PLANNING ADDENDUM

Bridgeway Centre, Wrexham Industrial Estate

Planning application: P/2022/0065

FI003-008v1

Extract LDP Proposals Map, 2023

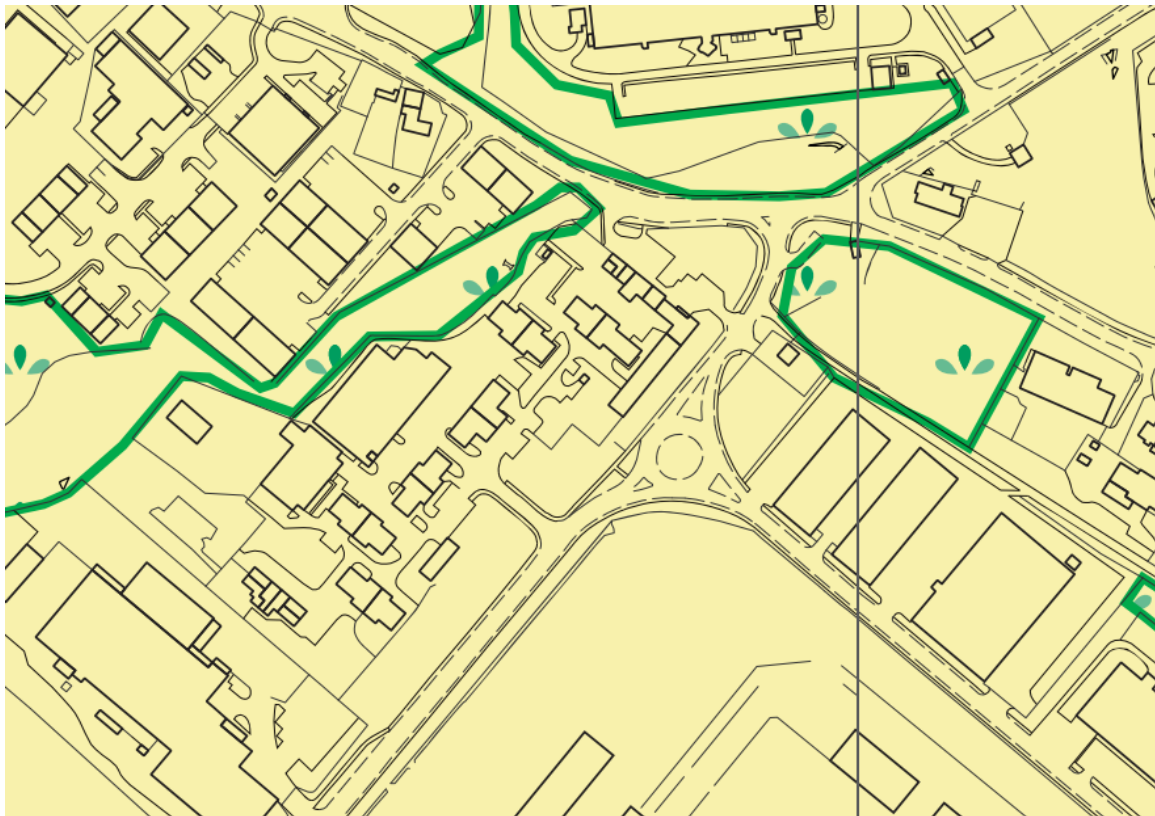
Site is subject to Policies SP2, SP8, SP9, EM1, MW6 and EM2 as an Employment Area

Policy SP9 Wrexham Industrial Estate Strategic Ecological Network applies to north/northwest edge of the main site and to the woodland that is proposed for offsite ecological mitigation (green line)
